UNITED STATES PATENT AND TRADEMARK OFFICE

APPLICATION NO.	FILING DATE	FIRST NAMED INVENTOR	ATTORNEY DOCKET NO.	CONFIRMATION NO.
10/686,857	10/16/2003	Andrew M. Hiles	HAM-100-A	1733

Office Action Summary	Application No. 10/686,857	Applicant(s) HILES, ANDREW M.	
	Examiner PAUL T. CHIN	Art Unit 3652

DETAILED ACTION

FIG. 3

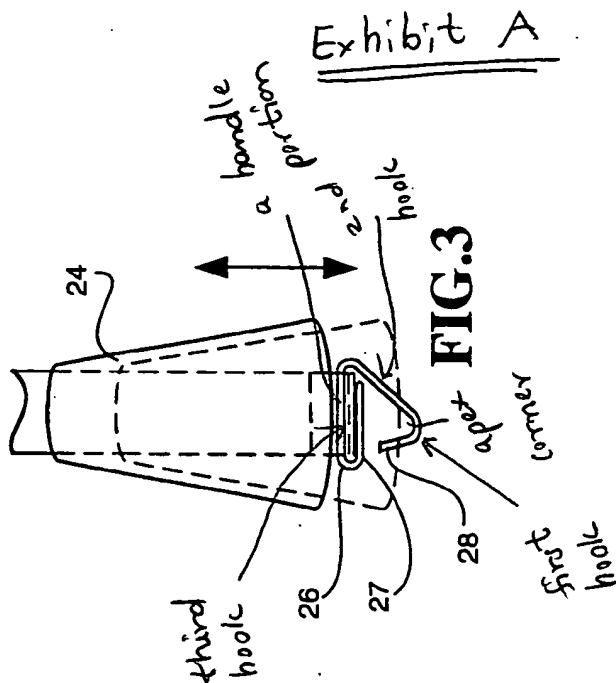
Allen et al. (5,448,805) discloses a device comprising: a one-piece unitary hook member (26) (Fig. 3) configured in a substantially triangular shape having a first end (28) and a second end (27); the hook member (**see Exhibit A**) having a first hook portion leading to an apex corner portion, a second hook portion, a third hook portion extending to a

handle portion; said hook member is provided with a predetermined opening between said first end portion and said second end portion; the apex portion being located the opposite from the handle portion; a strap member having a fabric nylon webbing (20) (Col. 2, lines 28-34) being connected to the hook member so that the strap member function as a connection attachment wherein the end portions of the strap are folded back secured for insertion therethrough the handle portion. Note that the device distributes an equal strength when being pulled. Allen et al. device (5,448,805) does not teach that the first end (28) of the hook member has a shape end portion being tapered in the range of 30 to 45 degree.

However, Roberts (2,353,850) teaches a hook having a handle portion and a shape end portion (see Figs. 2 and 5) having a tapered end in the substantially range between 30 to 45 degree. Accordingly, it would have been obvious to modify the first end portion of the Allen et al. hook (5,448,805) to be a shape or tapered end portion as taught by Roberts (2,353,850) so that the shape end portion of the Allen et al. hook (5,448,805) would perform well to handle objects such as freight boxes, and heavy objects. It is pointed out that the modified Allen et al. (5,448,805) contains all the structural elements as recited in claims 21 and 22 while the intended use (i.e. *for dragging a game animal and for gaffing a fish or marine animal*) is not patentably significant. Allen et al. device (5,448,805) would be capable of dragging or hanging objects such as freight boxes, heavy objects, game animal, fish, or marine animal.
